DESIGN ADVISORY BOARD Tuesday, March 14, 2017 at 3:00 PM Conference Room 12, City Hall, Burlington, VT Agenda

TO: Design Advisory Board
FROM: Scott Gustin
DATE: March 14, 2017
RE: 17-0825CA/MA, 85 North Avenue

Request: Construction of 43-unit residential building with associated parking and site improvements.

1 LEVEL 1 - PARKING

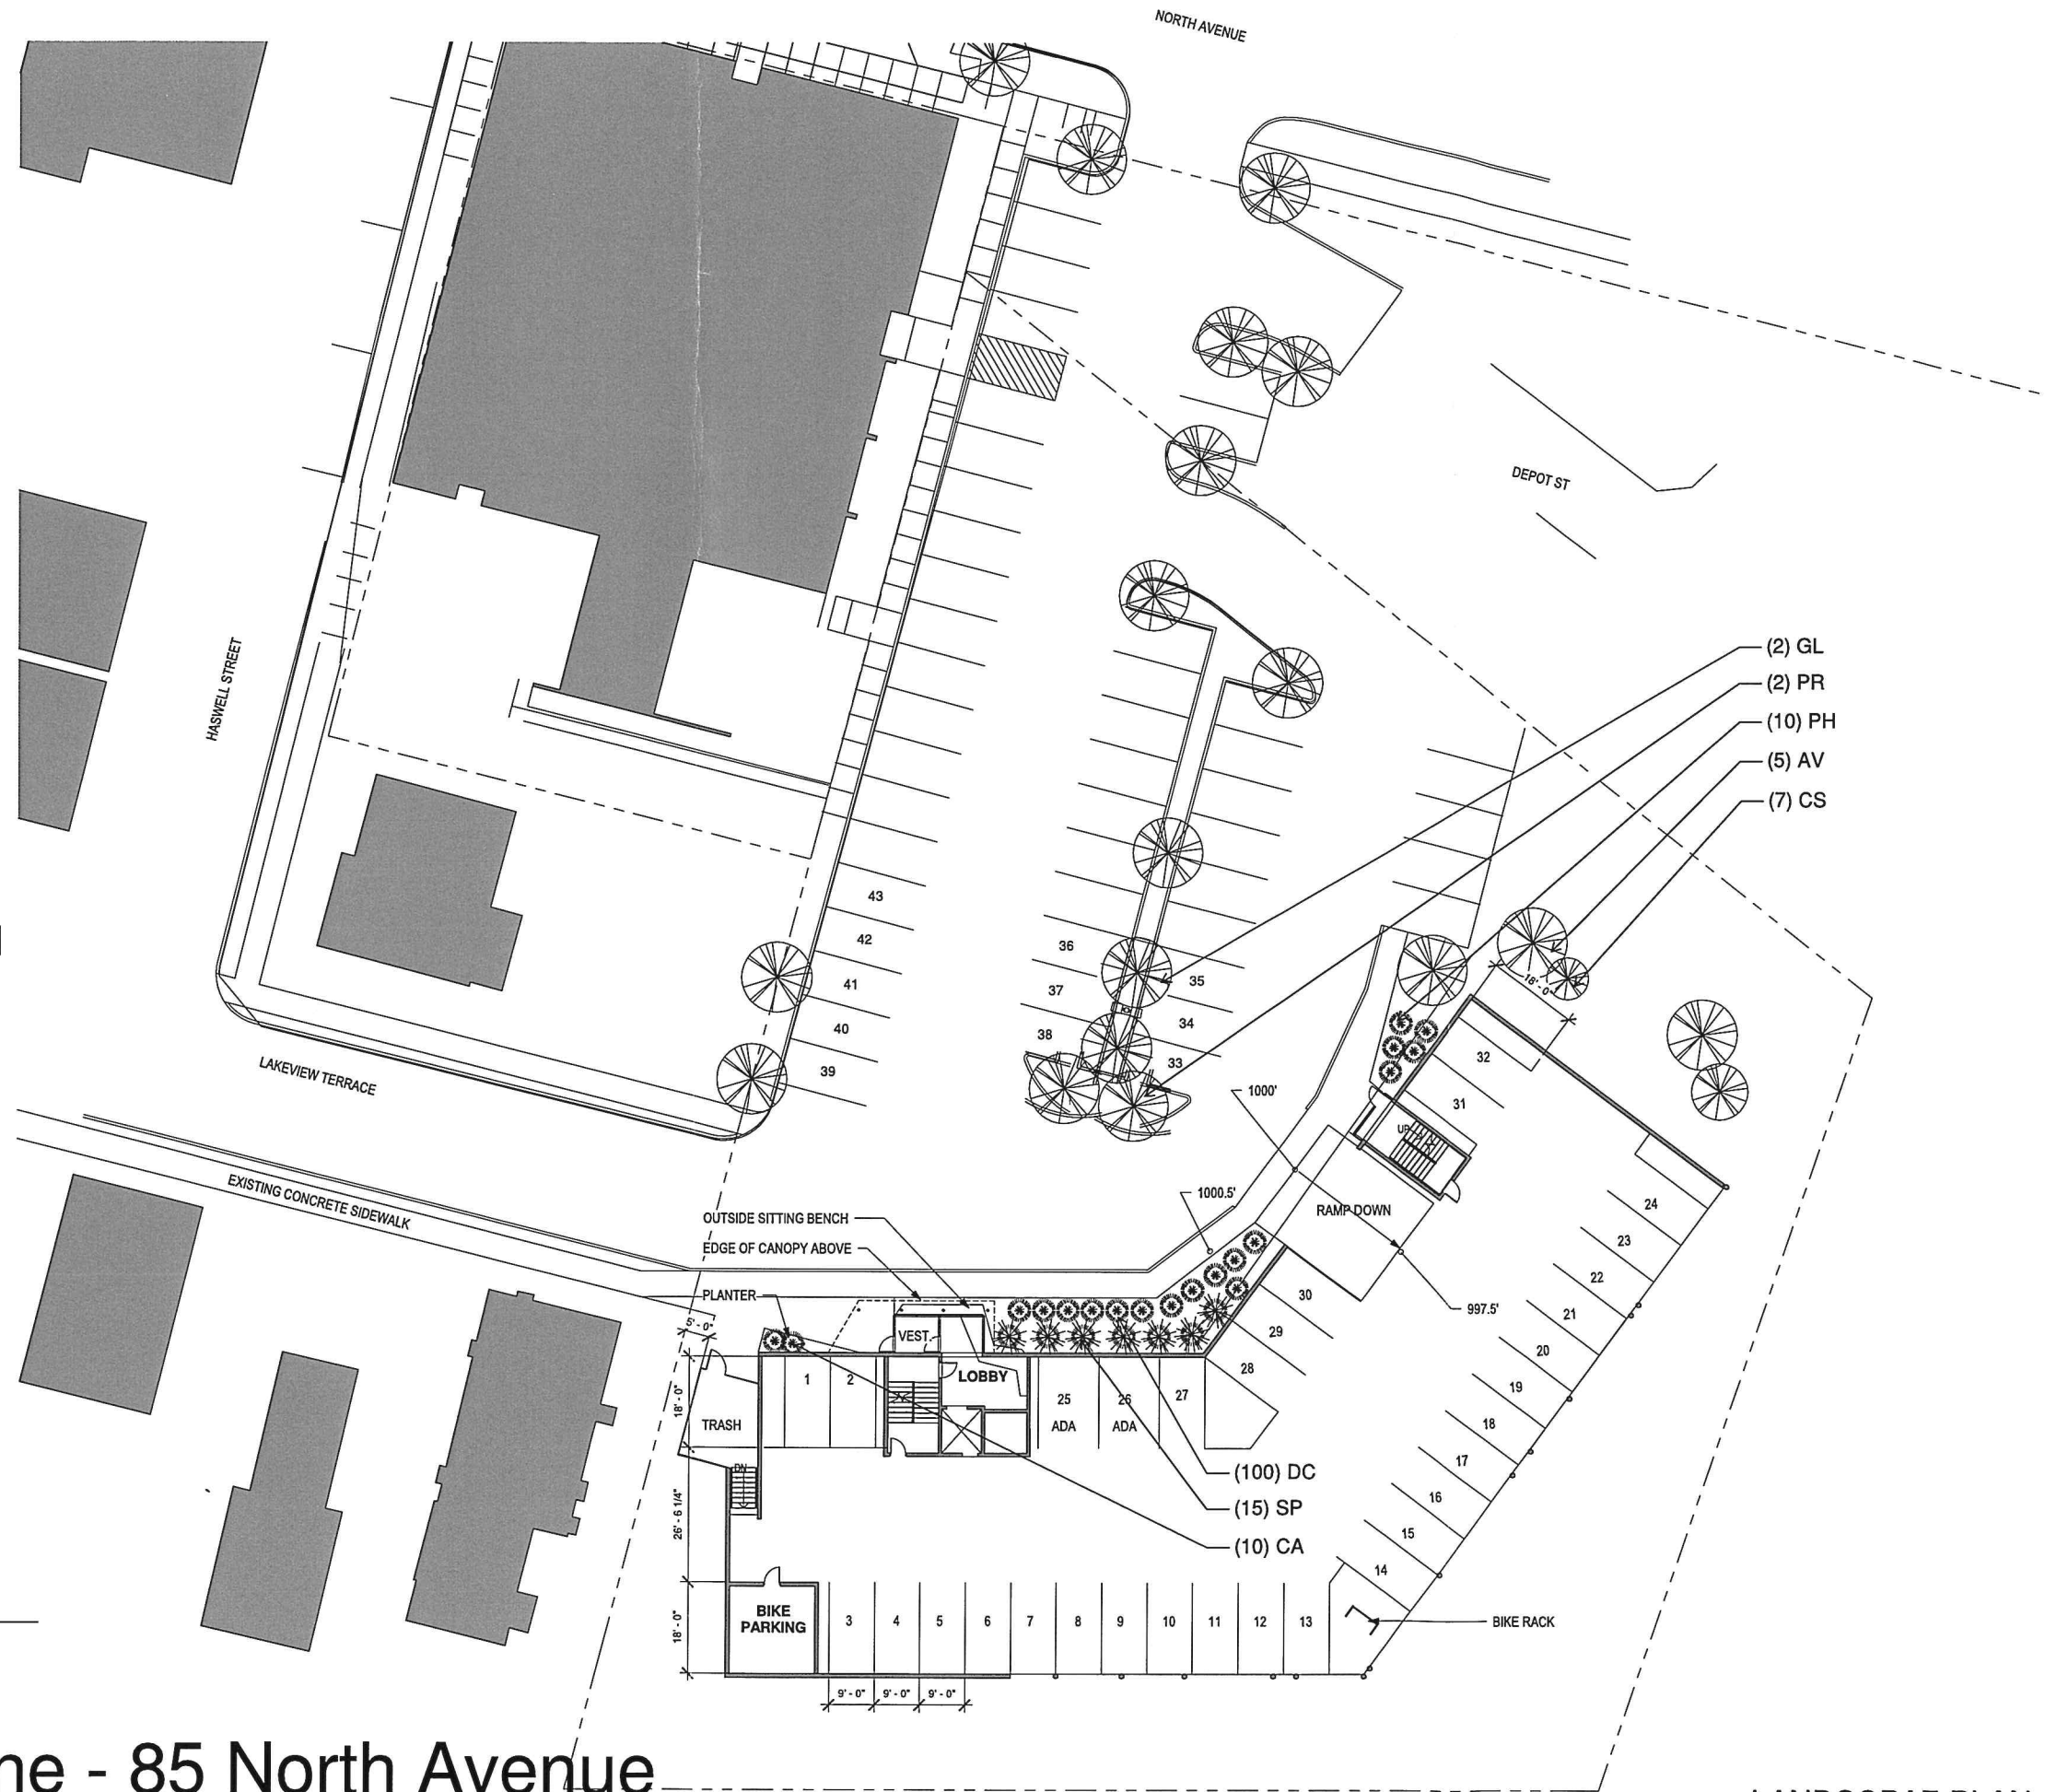
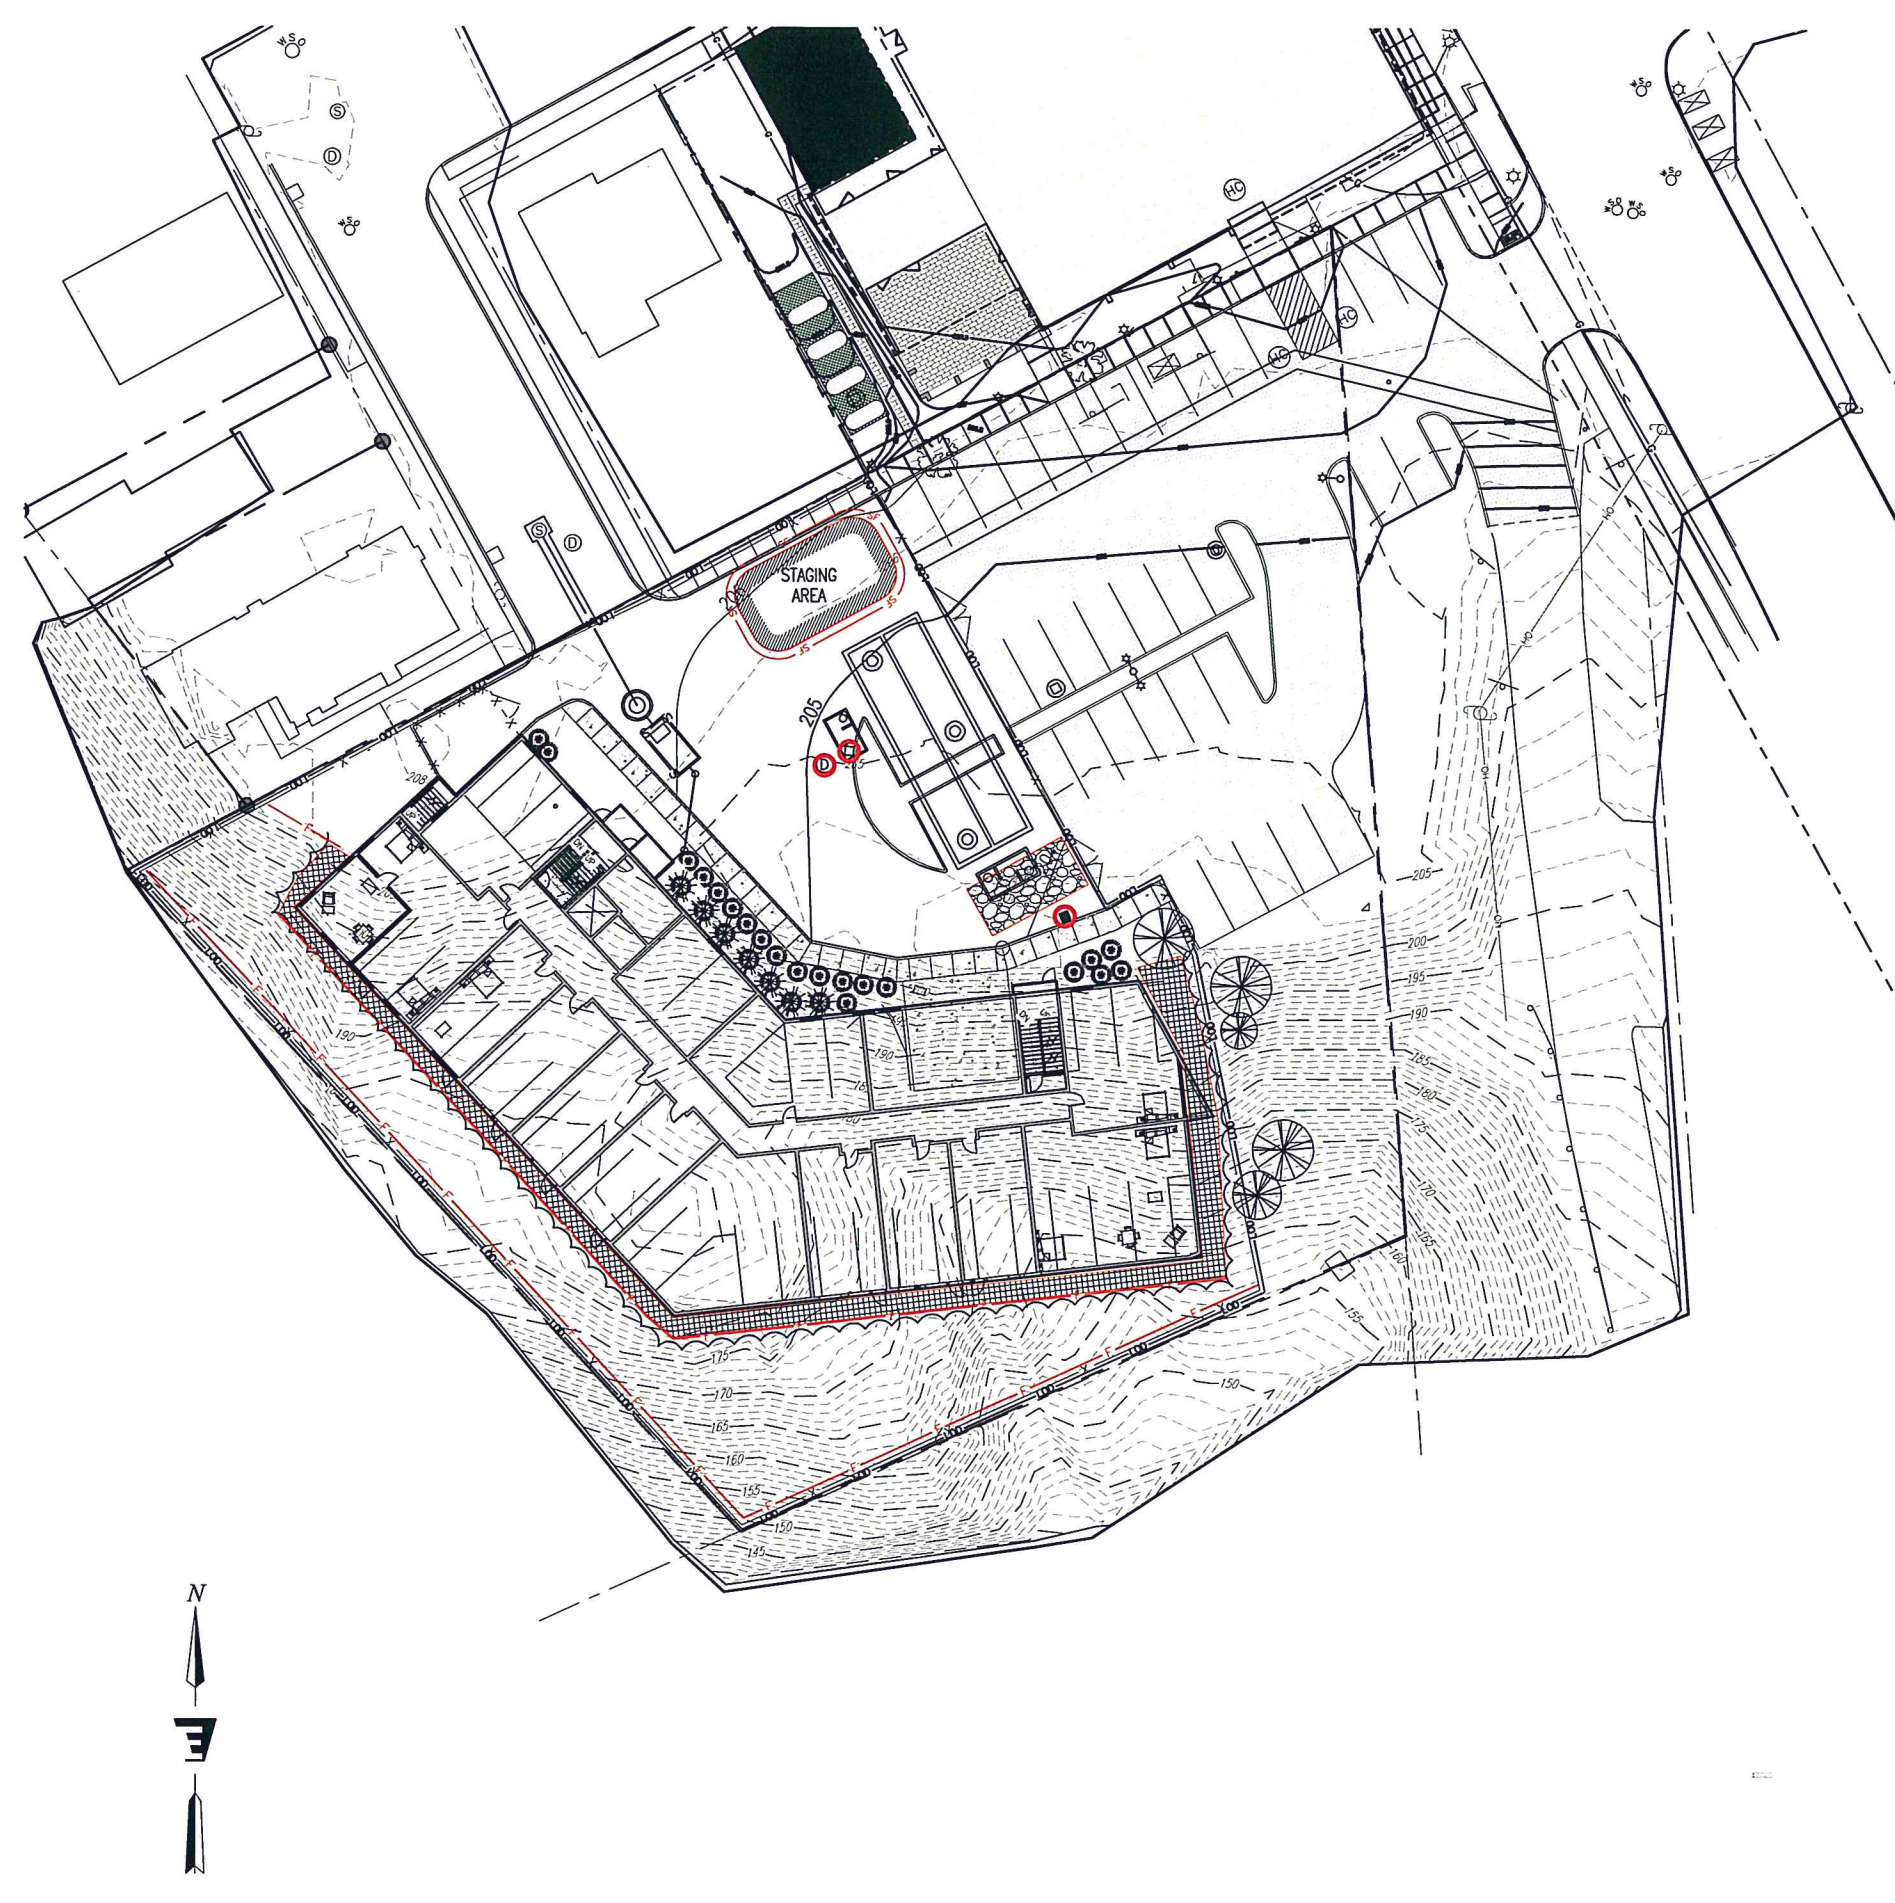
No information about the illumination of the garage is included in the application and must be. A fixture cutsheet must be provided along with illumination levels in order to confirm compliance with the applicable IESNA standard.

Render

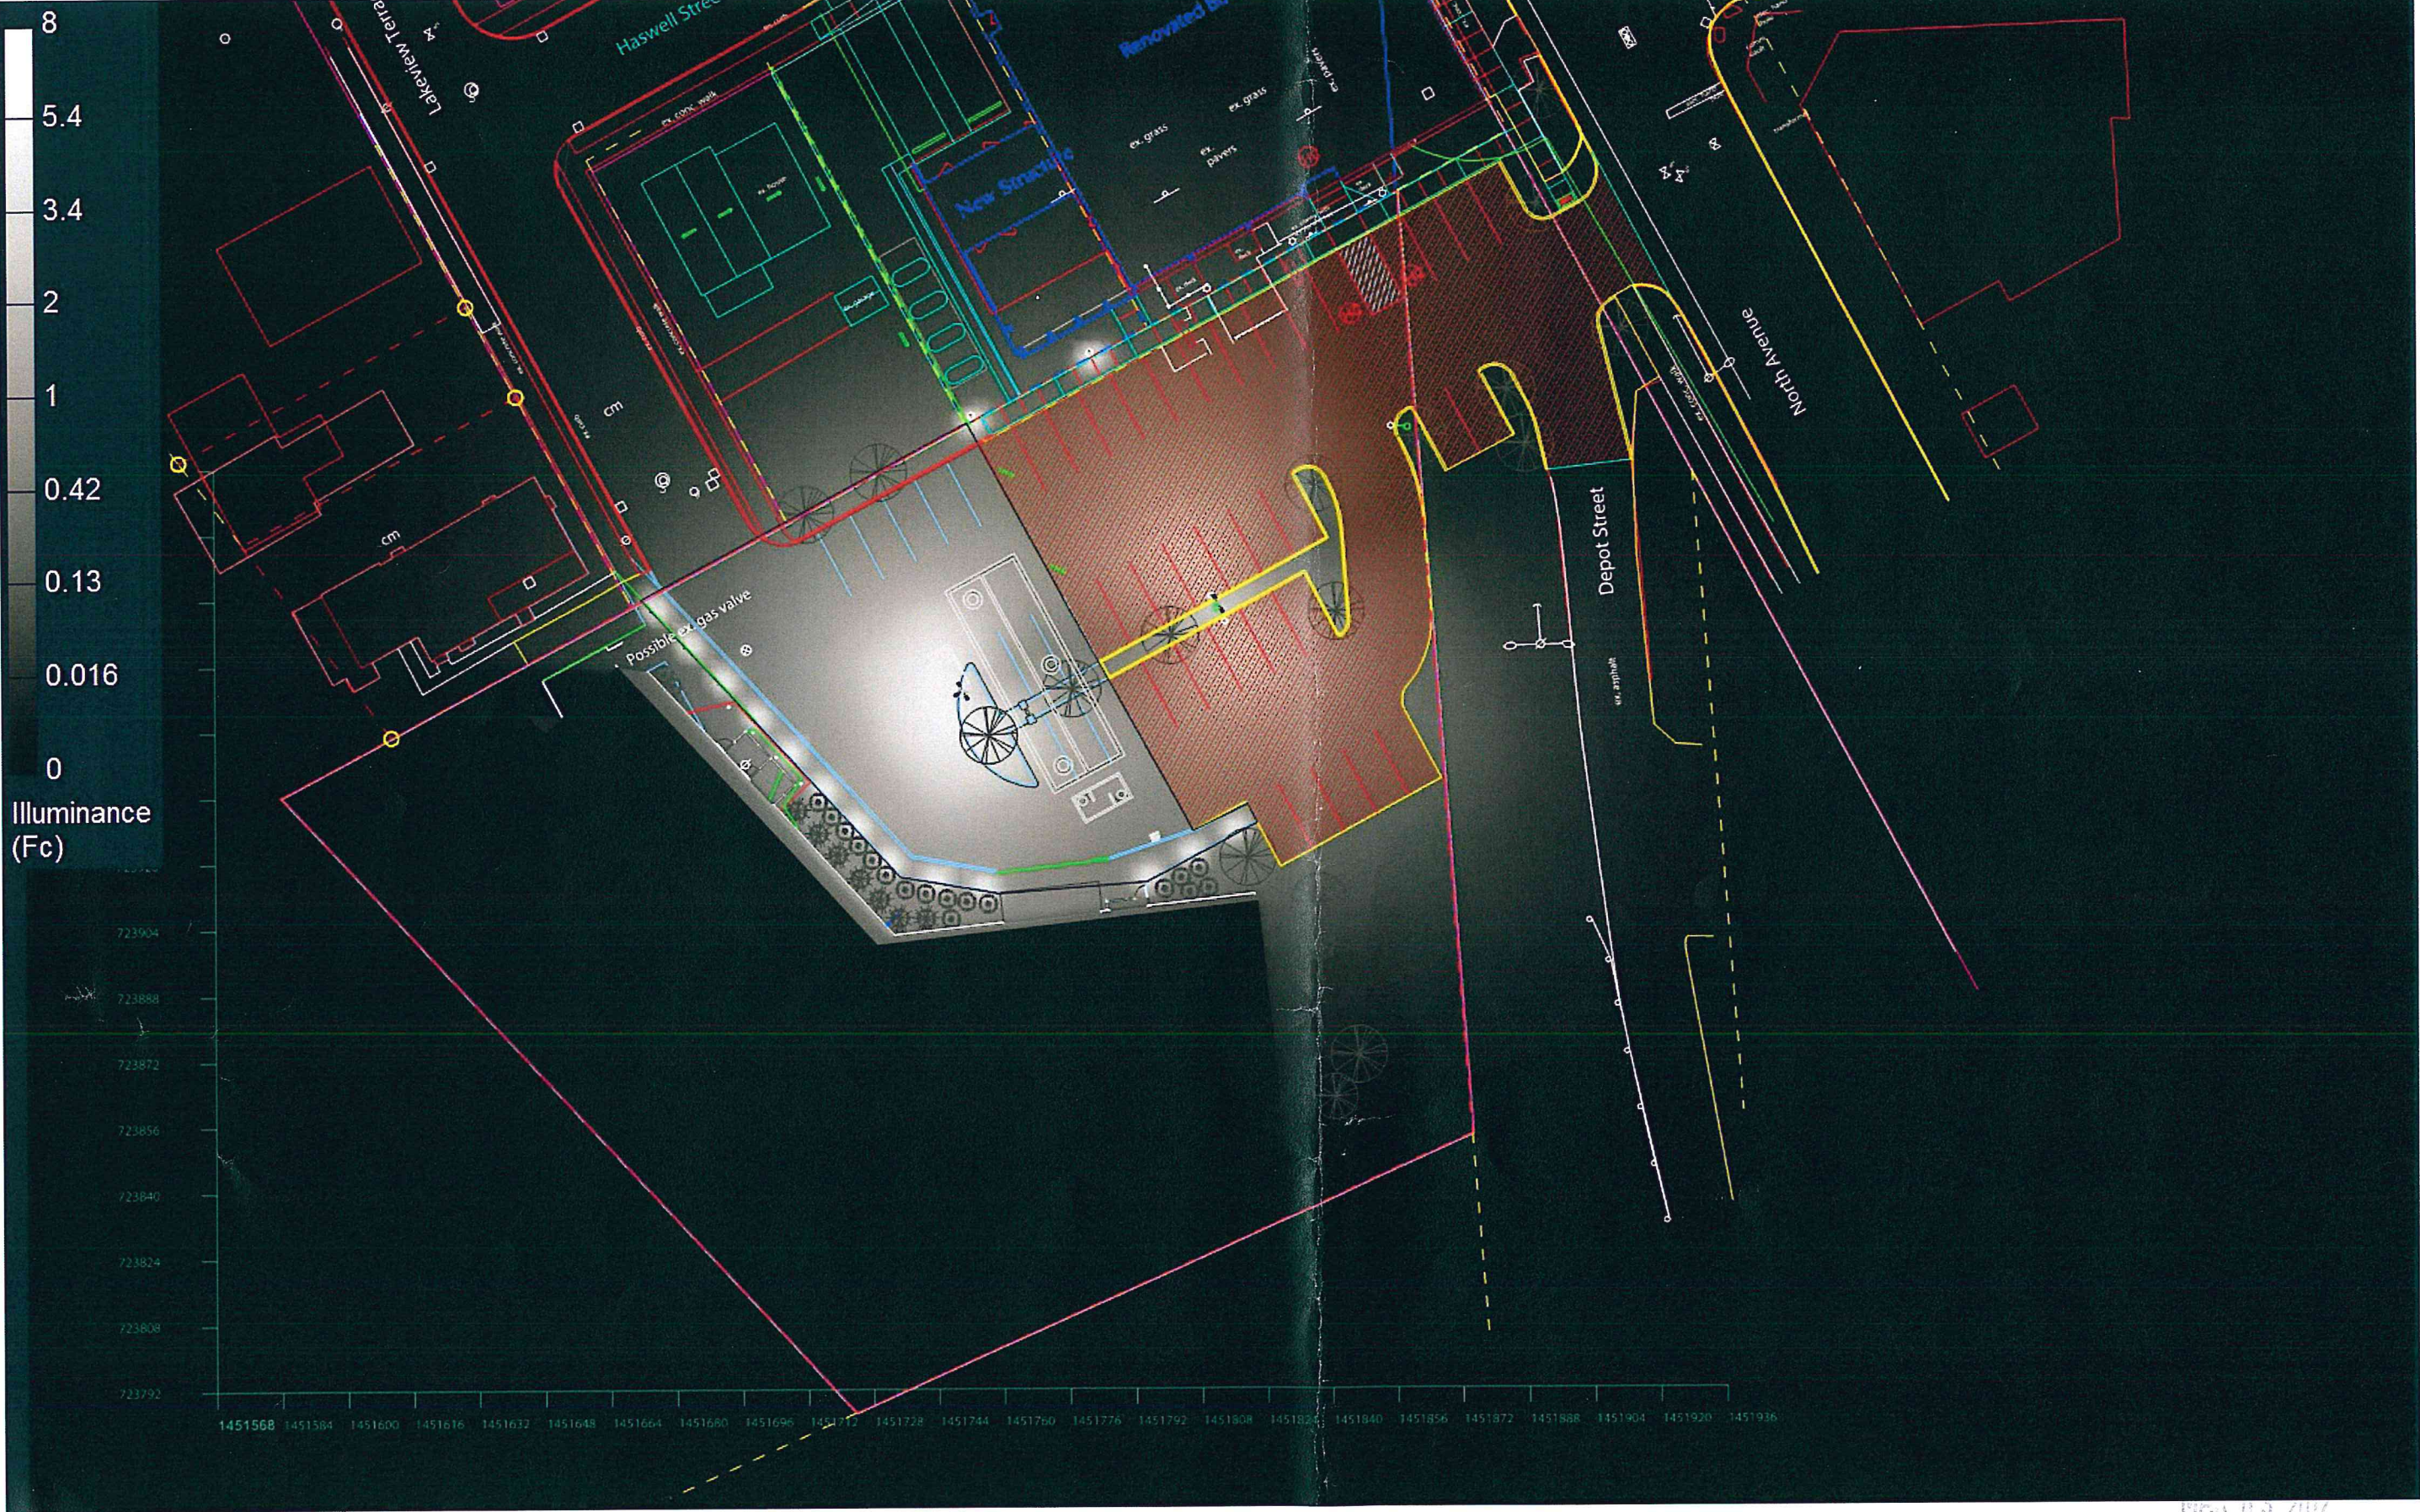
Outdoor lighting information has been provided, including a photometric plan and a fixture cutsheet for the surface parking area. The specified fixture is acceptable – a cutoff LED luminaire. Illumination levels; however, are too bright in places. There are several hot spots exceeding the 4.0 footcandle limit for surface parking areas. Lamp mounting height is acceptable at 20.'
